# Service Bulletin

Category <b>S</b>	Applicable Model/s <b>1995 Millenia</b>	Subject <b>REAR SEAT BACK RATTLE</b>	Bulletin No. <b>022/95</b>
			Issued <b>7/19/95</b>
			Revised

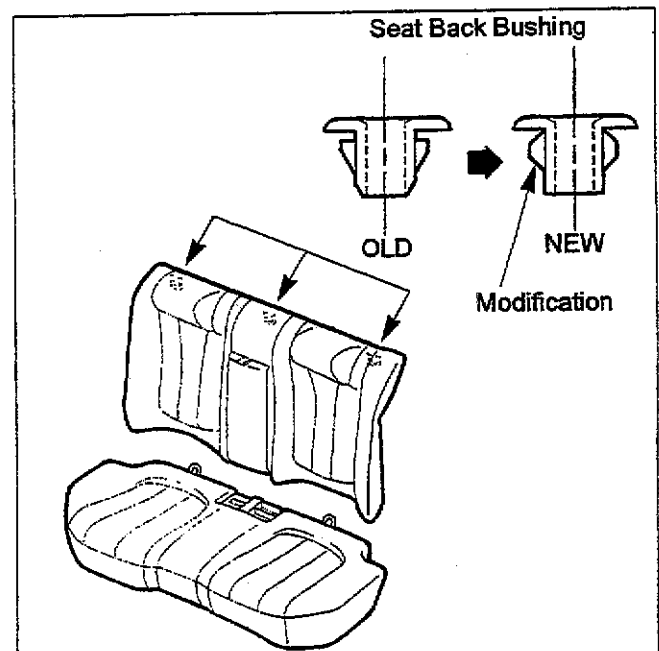
A rattle noise may be heard around the rear seat back when traveling on rough roads. This noise is caused by the seat back bushing. To prevent this noise, the bushing has been modified as shown below.

Customers complaining of this noise should have the bushing replaced with a new part.

1. Verify that the noise is coming from the seat back by applying pressure to the bushing area while the noise is occurring.
  - If the noise is coming from an area other than the seat back, refer to the workshop manual for troubleshooting and repair instructions.
2. Replace the seat back bushings (3 areas).
3. Confirm repair.
